Comment [e1]: NOTE TO LAR DEVELOPER:
Background information and, description of
transition process and figures are optional
information.

**Transition to 10 CFR 50.48(c) - NFPA 805
Performance-Based Standard for Fire Protection for
Light Water Reactor Electric Generating Plants, 2001
Edition**

Transition Report

Figure 4-6 Review POSs, KSFs, Equipment, and Cables, and Identify Pinch Points

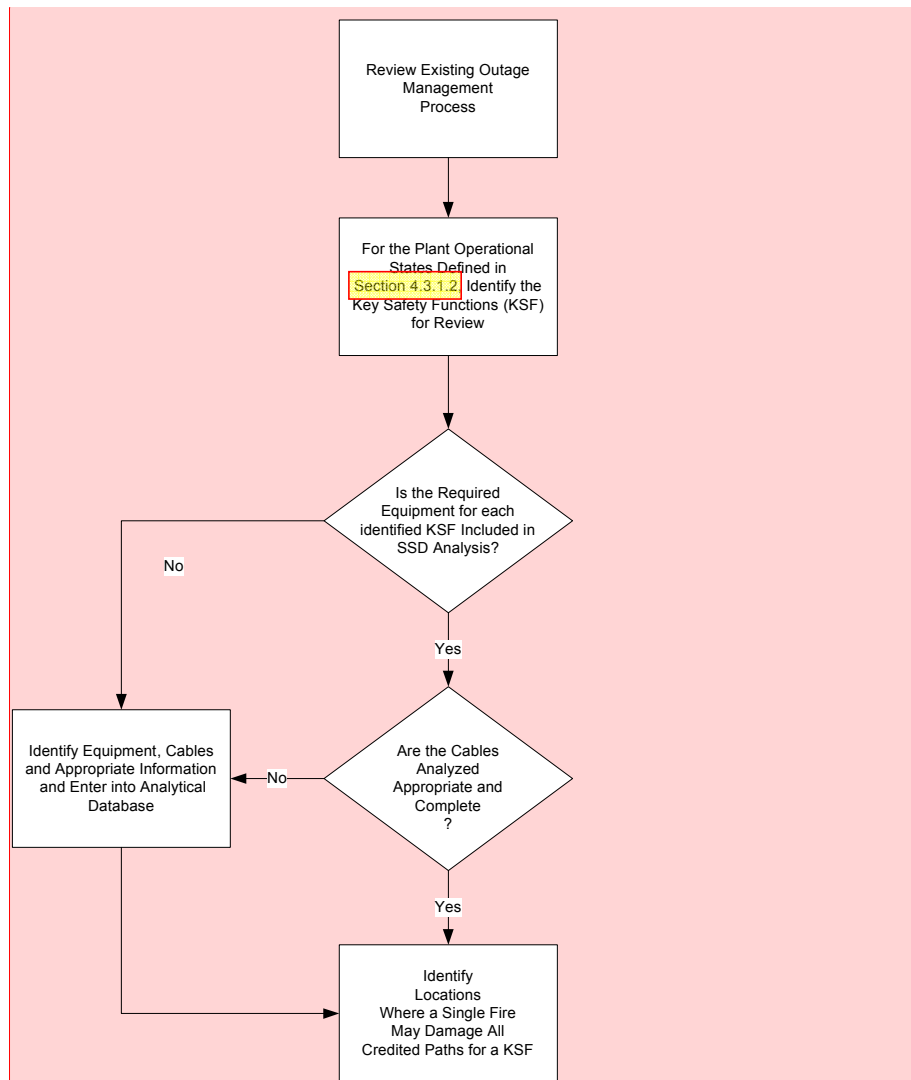
Comment [M20]: The reference in the second box (highlighted) is unclear. In Revision 4 to FAQ 40, the box references F2, the section on cable and component identification. This box seems to be self-referent. Suggest clarifying the source readers should look to for cable and component identification detailed guidance.
